**COMMONWEALTH OF KENTUCKY
TRANSPORTATION CABINET**

CALL NO. 308
CONTRACT ID NO. 185014
ADDENDUM # 1

Subject: NICHOLAS COUNTY, FD04 091 1096 000-001
Letting December 7, 2018

- (1) Revised - Title and Location Map Detail Sheet - Page 10 of 57
- (2) Revised - Typical Section Detail Sheet - Page 13 of 57
- (3) Revised - Proposal Bid Items - Page 57 of 57

PROPOSED TYPICAL SECTION

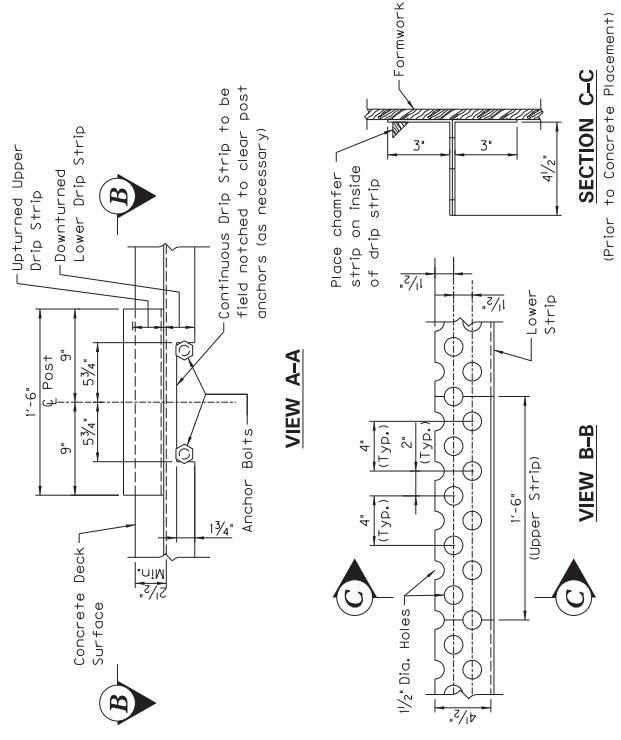
* Install Pavement Marking-Thermo Crosswalk 12" per Typical Continental Crosswalk Markings at the face of the Railing System on the East side of the bridge. See Detail A.
